KIAWAH RIVER PLANTATION (KRP) WASTEWATER TREATMENT PLANT (WWTP)

T&H PROJECT NO.
J-25328

ADDENDUM NO. 3

March 24, 2016

05-C-14A

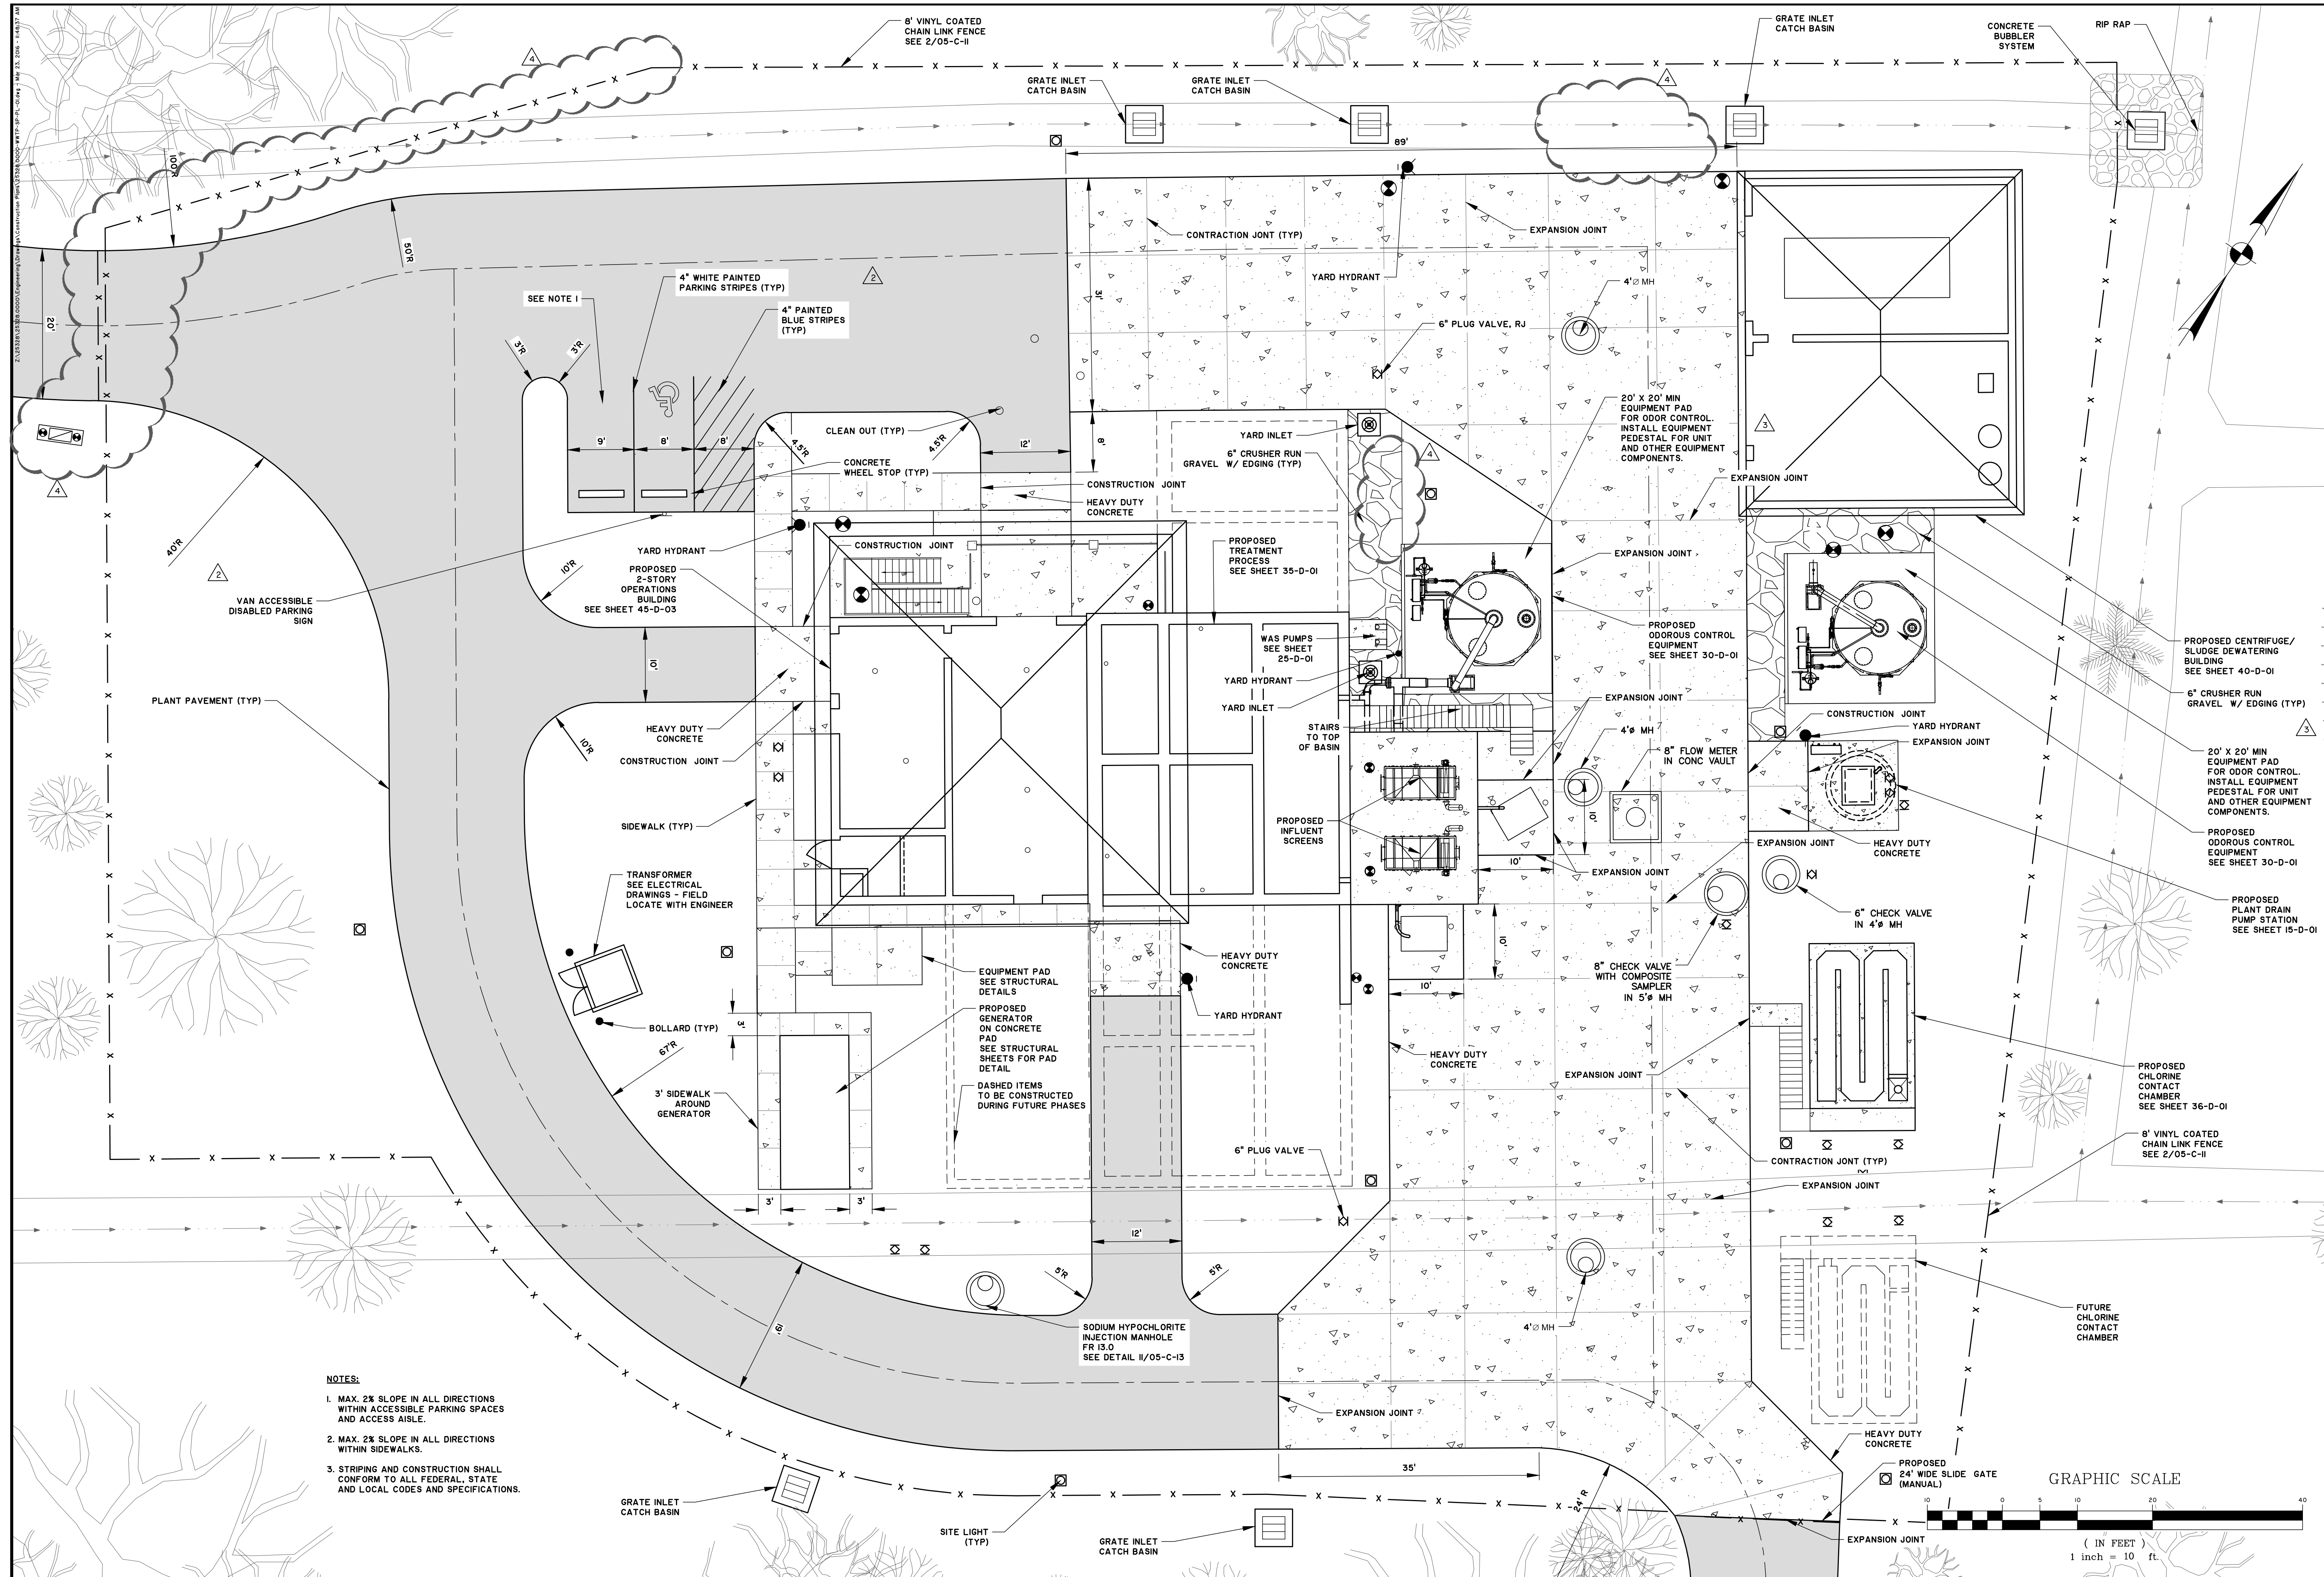
- 05-C-13 thru 05-C-14
 - 05-C-14A (added)
 - 06-C-01 thru 06-C-03
 - 07-C-01
 - 35-A-18
 - 36-D-01
- b. Add new Sheet 05-C-14A.
- c. Sheet 02-C-09 is deleted.

06-C-02

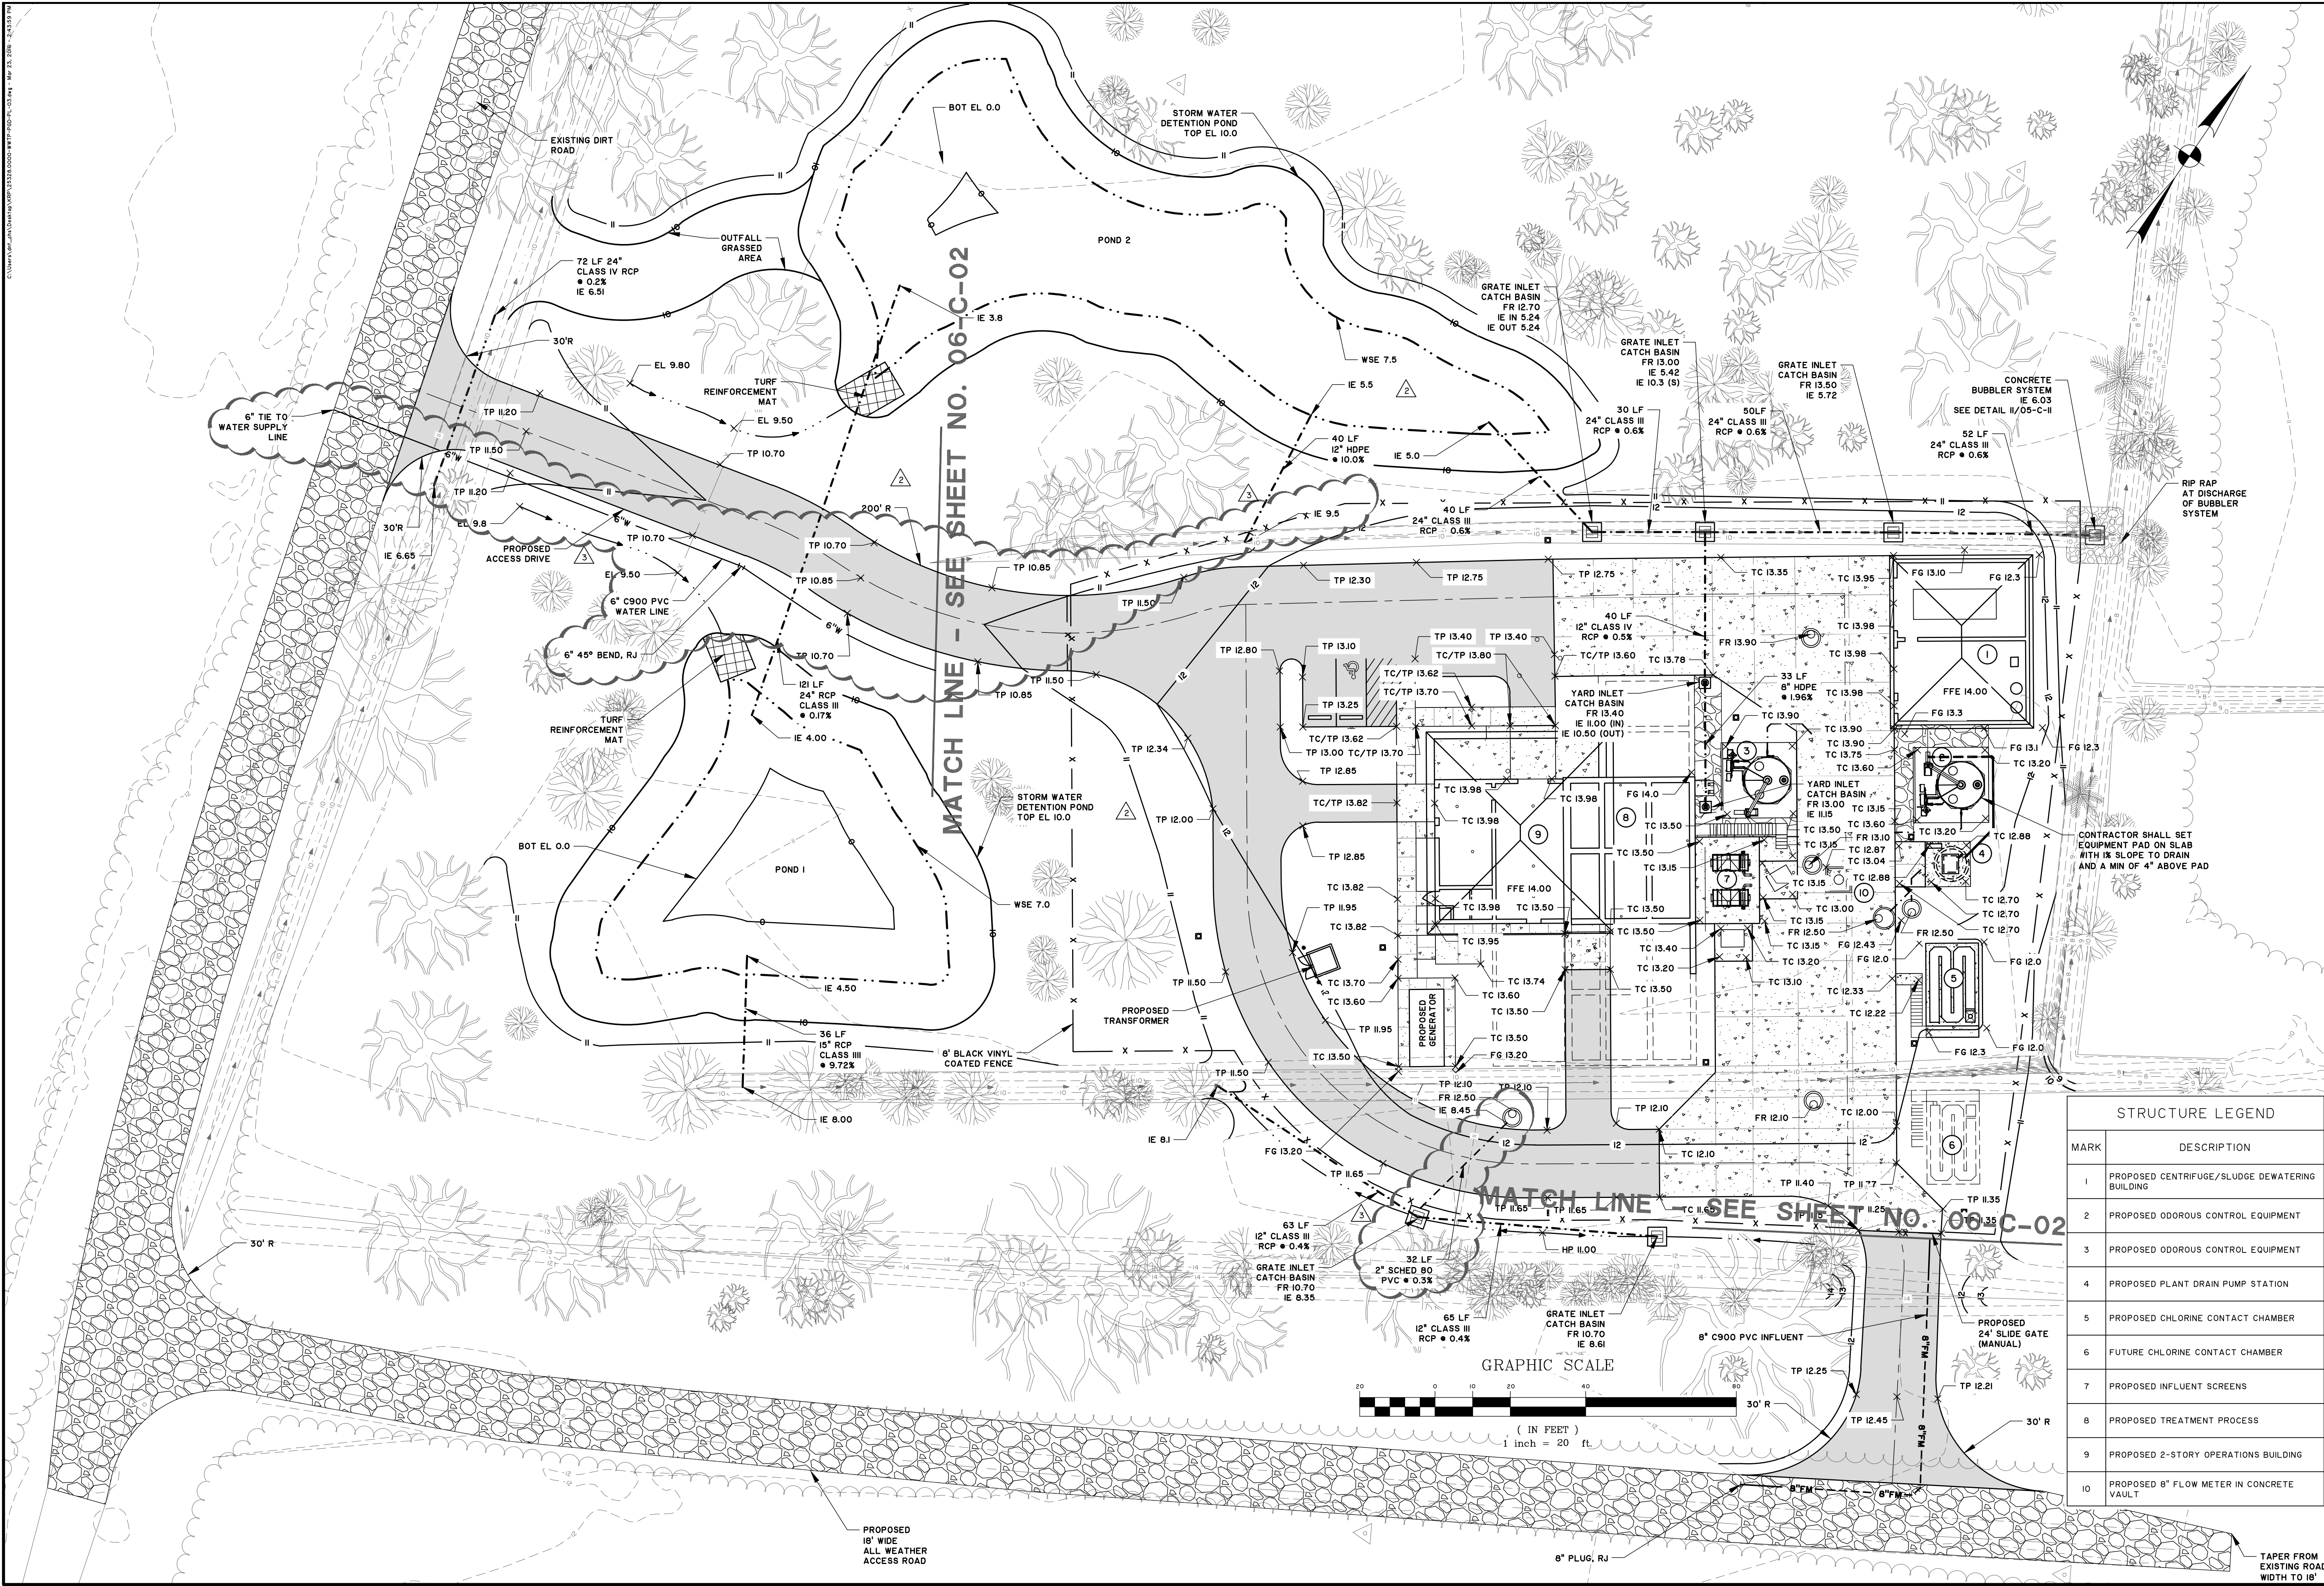
- f. Sheet 06-C-02
- Add Note 4, "All manholes shall be coated with 125 wet film mils of Raven 405 ultra-high build epoxy or an acceptable equivalent".
2. Specifications
